Subject: Re: Box curb vs. Roll curb

**SITE PLAN**  
**MDAT, LLC**  
 7-PLEX TOWNHOUSE BUILDING  
 MAGNOLIA TRACE UNIT 1, LOT 6

UTILITY PLAN  
MAGNOLIA TRACE  
MAGNOLIA WAY

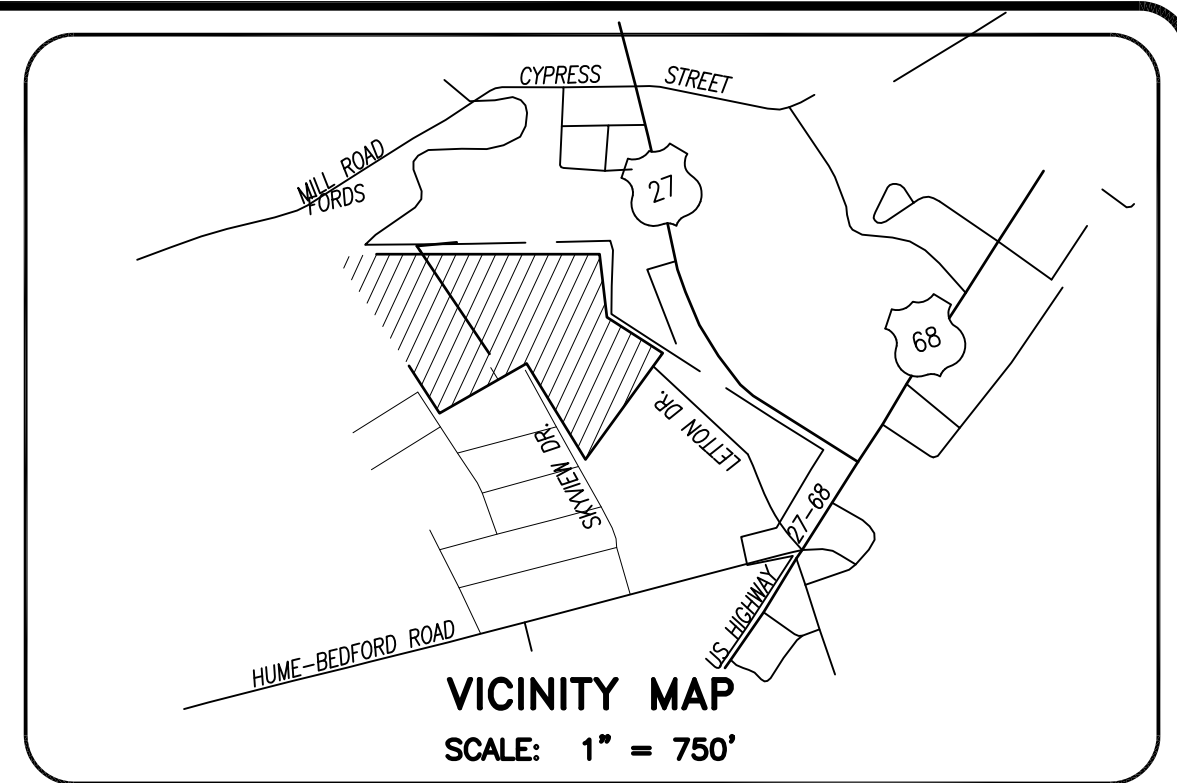
We are requesting to install rolled curb in front of the multi-family units as the front of the units consist of concrete driveways. If we use box curb, we would have to cut out the yellow portion and pour rolled curb in their place anyway. We will install box curb on Magnolia Way.

The design of all of our storm water collections systems presumes that rolled curb will be used. We do not use box curb unless the final authority that is responsible maintaining the street system requires box curb. We do not recommend that box curb be used in areas that are to be developed because of the number of times that the curb needs to be cut for driveways. Further, the rolled curb has the same water handling capacity as box curb.
